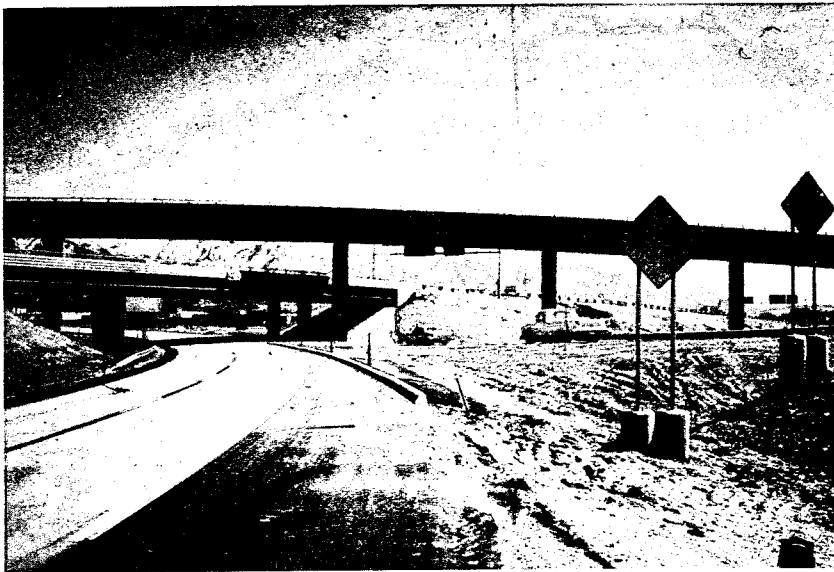
And I guess another similar type problem. These could be at least placed on breakaway supports.

Mr. TURNER. They should be placed on wooden posts that would break when hit.

Mr. W. MAY. Apparently those guardrail installations were designed to protect the motorist from striking the center pier, and it appears it won't quite do it, but this could be corrected easily with not too much expense.
